# Access Compliance Report

## Public Rights-of-Way

### (Curb Ramps)

Intersection ID: 24072	Main Street: DELOACH_CT	Cross Street: HAWK_CREST_CT	Location: S
ADA ID: 4D19D5109EB2	Ramp Type: PerpDiag	Initial Pass/Fail: Fail	Overall Compliance: No
Severity Score: 21.25			
Codes/Mitigation Info/Possible Solution		Field Measurements/Component Compliance

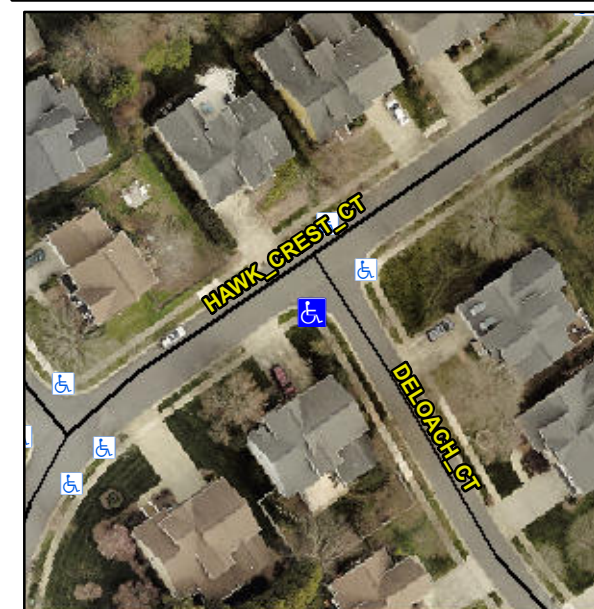
**Not Found, R304.5.1, R304.5.3**

Compliance	Description	Data	Compliance	Description	Data
N/A	Ramp Length (in)	48.0	Yes	Ramp Slope (%)	5.1
No	Ramp Width (in)	37.5	No	Ramp XSlope (%)	5.2
N/A	Flare Type LT	N/A	N/A	Flare Type RT	N/A
N/A	Flare Slope LT (%)	N/A	N/A	Flare Slope RT (%)	N/A
N/A	Flare Traversable LT?	N/A	N/A	Flare Traversable RT?	N/A
N/A	Landing Length (in)	N/A	N/A	DWS Provided?	N/A
N/A	Landing Width (in)	N/A	N/A	DWS Contrast?	N/A
N/A	Landing Slope (%)	N/A	N/A	DWS Length (in)	N/A
N/A	Landing X Slope (%)	N/A	N/A	DWS Full Width?	N/A
N/A	Landing Curb? (Y/N)	N/A	N/A	DWS Offset (in)	N/A
N/A	Shared Landing?	N/A			
N/A	Gutter Ponding?	N/A	N/A	Gutter Slope (%)	N/A
N/A	Gutter Lip Ht (in)	N/A	N/A	Gutter X Slope (%)	N/A
N/A	Painted X Walk1?	No	N/A	Painted X Walk2?	No
	X Walk 1 Direction	To NE		X Walk 2 Direction	To NW
N/A	X Walk 1 Width (in)	N/A	N/A	X Walk 2 Width (in)	N/A
	X Walk 1 Slope (%)	6.4		X Walk 2 Slope (%)	3.9
	X Walk 1 X Slope (%)	0.8		X Walk 2 X Slope (%)	7.7

N/A	Ramp inside XWalk1?	N/A	N/A	Ramp inside XWalk2?	N/A
	Road Slope (%)	4.6	N/A	Clear Space?	N/A
	Road X Slope (%)	7.7	N/A	Clear Space to XWalk (in)	N/A
N/A	Any Obstructions?	N/A	N/A	Storm Grate/Utility Hazard?	N/A
	Obstruction Type			Storm Grate/Utility Type	
		N/A			N/A
			Yes	Surface Condition? (G/P)	Good

**Remove & Replace Curb Ramp With Two New Directional Ramps or Equivalent.**
